3.5.11 Pre-application meeting 3 feedback

The following pages set out the comments received from officers and detail how the design developed to respond to those comments:

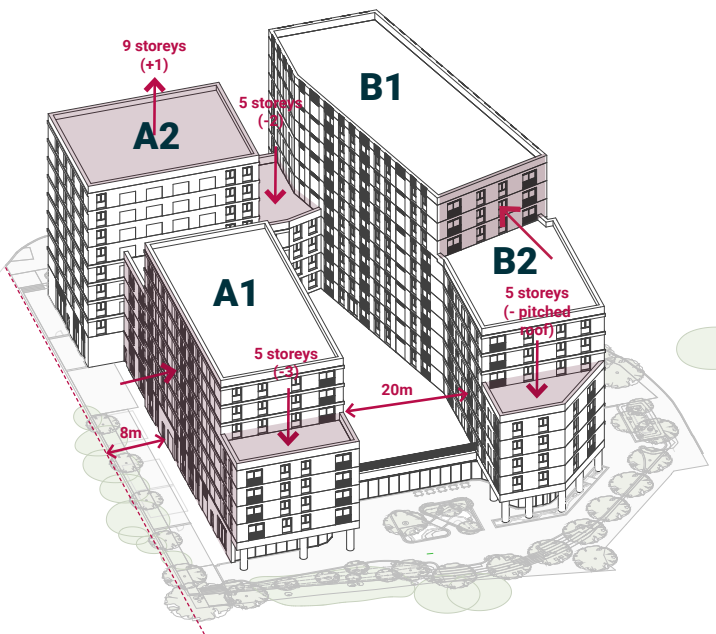
Building footprint - Form and layout of the proposed development does not respond positively to the site and surrounding area, with tall, dense urbanisation via a city block. Exploration, evolution and justification over other forms not given.

Buildings A1, A2 and B2 have been slimmed to 17.5m in width. Building heights have been further refined to create a 5 storey datum to the links creating further separation between the buildings and buildings A1 and B2 step down to 5 storeys on the river.

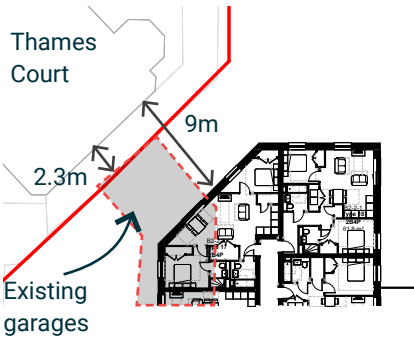
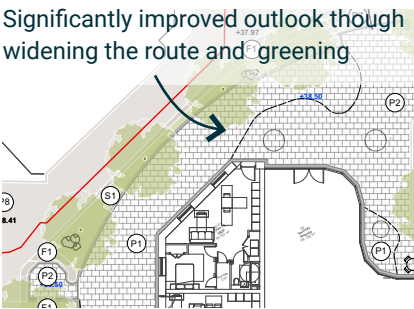
Proximity to Clearwater Court - Visual outlook, dominant/overbearing, daylight/sunlight, redevelopment. Increase to 8-10m from boundary

Proximity to Thames Court - Detrimental amenity impacts for occupiers, privacy/overlooking, outlook/sense of enclosure, visual dominance, daylight and sunlight.

Distance from the boundary has been increased to 8m.

At it's closest point, the proposal is 9m from Thames Court. SL/DL studies have been undertaken and the impact is considered minimal for a small number of secondary windows. Moreover, if the 45 degree test is applied in plan the building does not break the line.

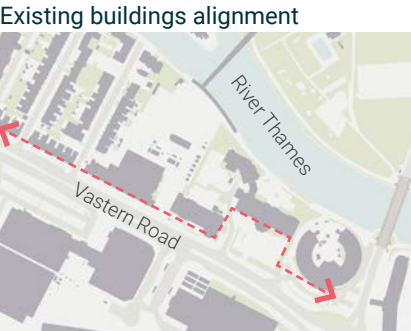
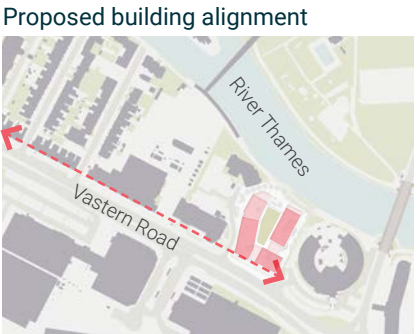
Vastern Road alignment - Building further back from Vastern Rd - prevailing / future (55 Vastern Road) context

Vastern Road building alignment is designed to respond to the primary frontage and is positioned in line with 55 Vastern Road frontage.

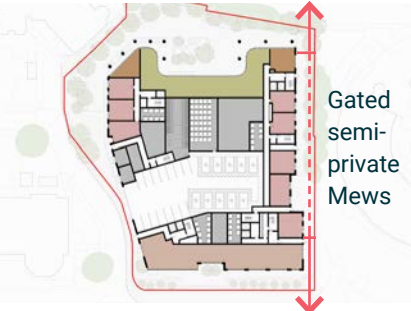
Eastern boundary units - Gating of the external space

Noted. Mews street has been developed to be open with entrance porches providing dedicated external entrances for apartments along the east. This creates interest at street level as well as private amenity space for residents at first floor. Whilst the space is not gated, it still provides an alternative amenity space for children to ride bikes / play and provides defensible space for residents at ground floor. The space is framed by mature trees and affords views of the river. The street is a quieter secondary route to the river.

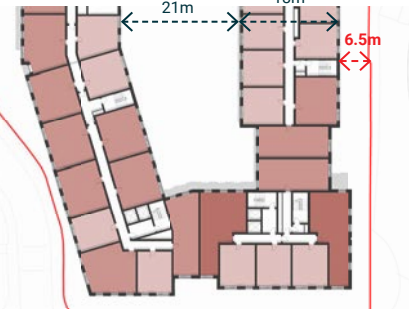
Podium Width - Overlooking and loss of privacy concerns. 20m minimum

Predominant distance across the courtyard is 20m, this does narrow towards the south however, A1 is inset at this point and B1 is positioned at an angle to avoid direct overlooking. The narrowest point is 15m which is not uncommon in urban settings. Defensible space is provided to apartments at courtyard level. Angled apartments will benefit from a river view. Apartments to the east benefit from being dual aspect.

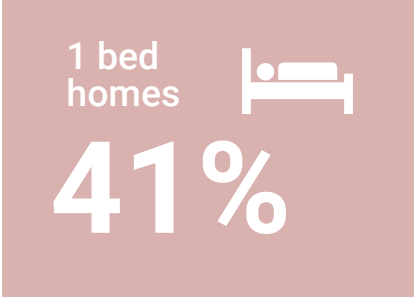
Podium Use - Harm to occupiers of units facing podium from possible noise, disturbance, overlooking and loss of privacy

The podium gardens will be designed to provide defensible space to residents directly fronting the podium. The intended uses will be considerate of potential noise and privacy issues for residents with more active amenity spaces provided at 8th floor. Calmer more reflective uses proposed to the courtyard space at first floor.
